# STAFF RECOMMENDATION

NCPC File No. 6179

## AMERICAN VETERANS DISABLED FOR LIFE MEMORIAL

September 25, 2008

**PRELIMINARY PLANTING PLAN**

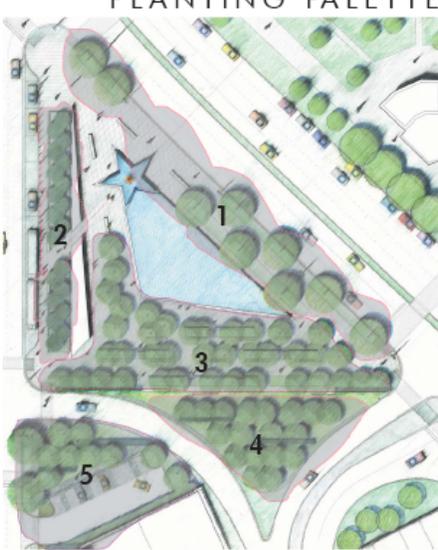
- **Material samples for stone and glass elements.** Materials should be durable and able to withstand weathering and heavy use. Additionally, stone materials used for the fountain and reflecting pool should retain their character when either wet or dry.
